**AGENDA FOR THE REGULAR MEETING OF THE
DESIGN REVIEW SUBCOMMITTEE**

**Wednesday, May 14, 2014
10:00 a.m.**

B. Conditional Use Permit 13-249/Architectural Permit 13-251/Site Plan Permit 13-252, La Ventura Event Facility (Gregg)

SUBJECT: CUP 13-249/AP 13-251/SPP 13-252, La Ventura Event Center, a request to consider modifications to a previously reviewed commercial building for a special event facility totaling 5,456 square feet at 2316 South El Camino Real.

Driveway Elevation

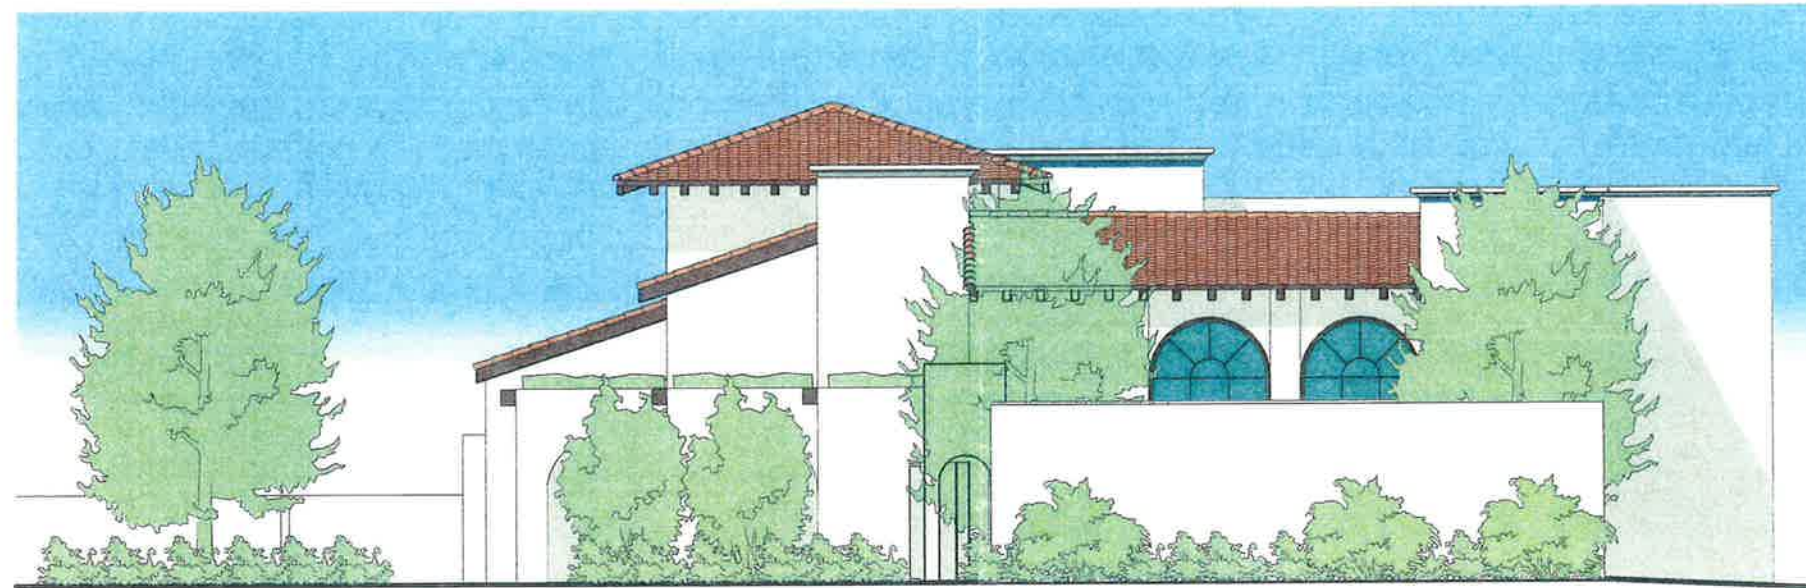
The applicant did not modify the courtyard wall but did enhance the first half of the two-story building. The applicant added inset arches and framed details to help break up the vast area. The applicant stated that expansion joints would be needed on the building. The Subcommittee discussed previous use of expansion joints and stated that the joints would have to be architecturally placed and hidden by landscaping. Subcommittee Member Kaupp suggested using Italian Cypress because of its lines and height.

El Camino Real Elevation

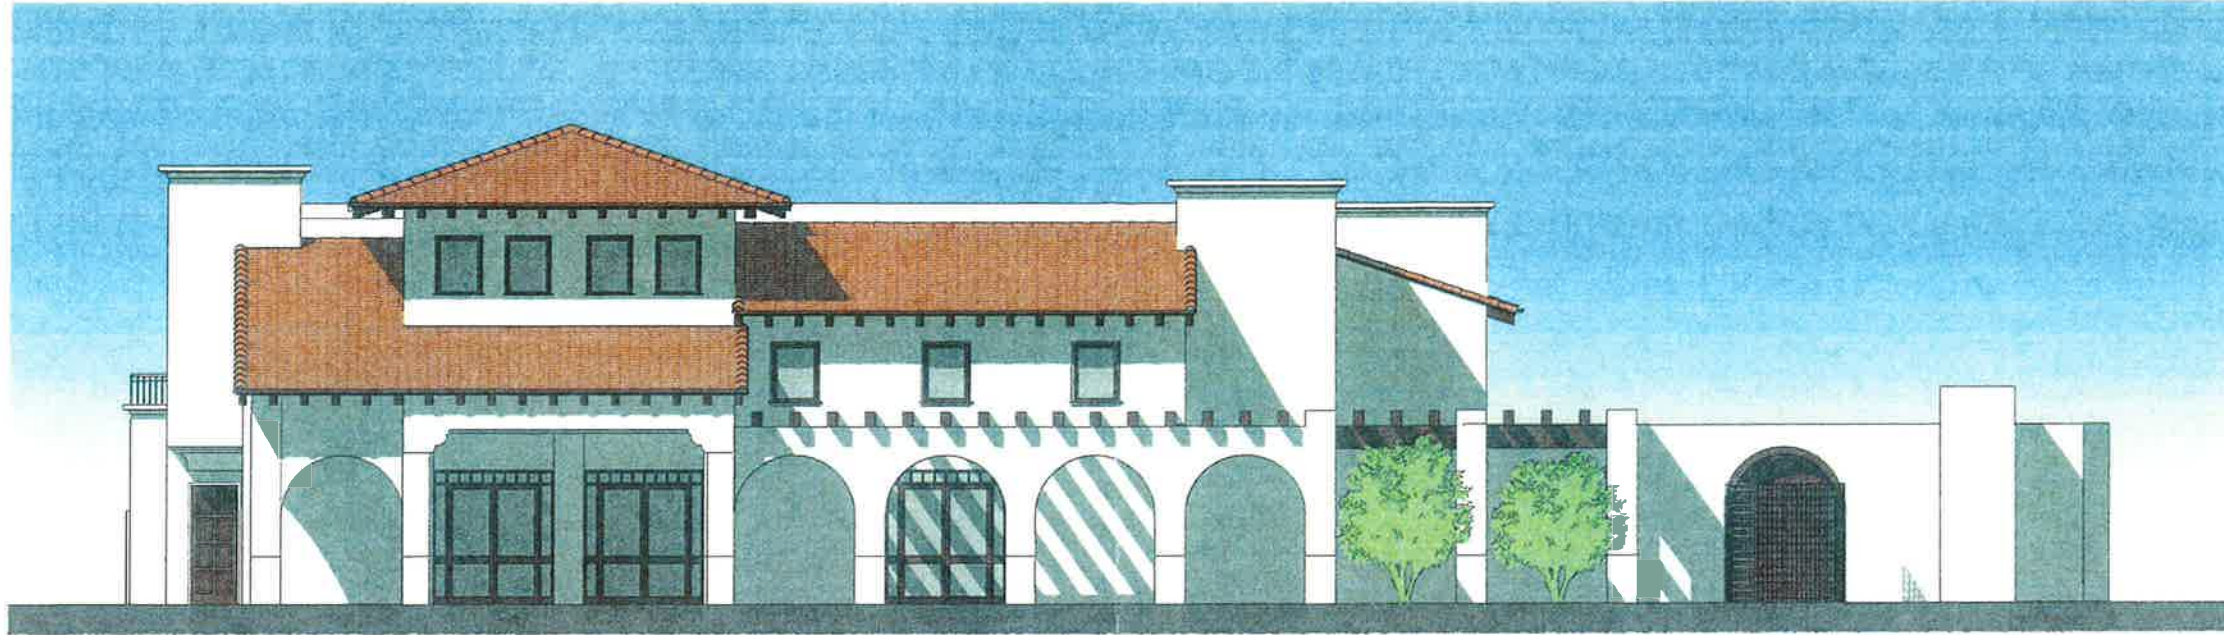
1. The main entry into the building has a bowed, faced portico. Staff recommends a squared-off portico to be consistent with Spanish Colonial Revival style.
2. Staff has concerns with the treatment of the north elevation. The applicant did incorporate a design out of the control joints, but the number of joints is numerous. Staff would recommend reducing the number of control joints.
3. Also on the north elevation, the applicant incorporated trellises and foam details to provide relief. Providing two, stacked elements breaks up the building. Using a taller element creates a more vertical design, typical of Spanish Colonial

Applicant added inset arches with decorative tile in the inset. Applicant stated that they will also incorporate revised landscaping to add extra interest and appeal to the streetscape. DRSC liked the modification and discussed appropriate signage locations on the building. Subcommittee Member Kaupp informed the applicant of tile murals that had event scenes. The applicant was very receptive to this idea and thought it would tie in nicely with the project. Lighting of the murals was also discussed.

Parking Lot (Rear) Elevation

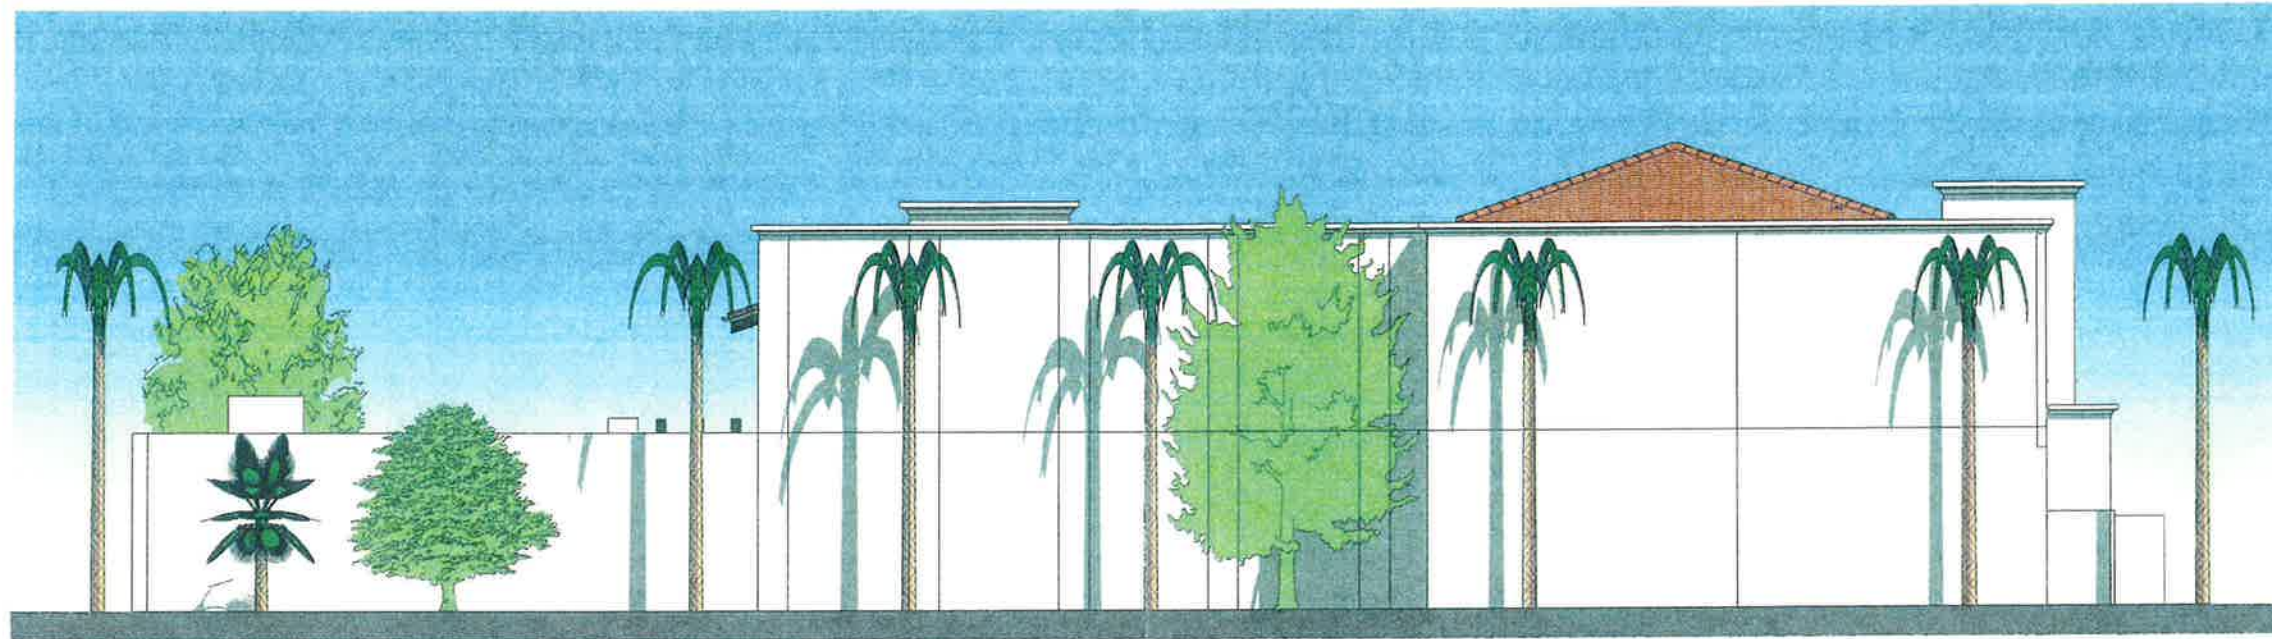
11. The rear elevation also suffers from lack of detail. Per City Design Guidelines and General Plan all buildings should have 360 degree architecture.
12. The plans identify an awing with decorative iron spires but they are not shown on the colored elevations, and are hard to make out on the full size plans. Please show on all plans.
13. There is opportunity to include architectural and landscape accents including trellises and decorative gates on the trash enclosure to provide interest.
14. The entire landscaping strip at the back of the parking lot, adjacent to the residents should be landscaping. Staff recommends removing the paving and adding additional landscaping.
15. The landscape area between the residents and the parking lot could benefit from move vertical landscaping or more trees to help buffer the space between the cars and the residents.
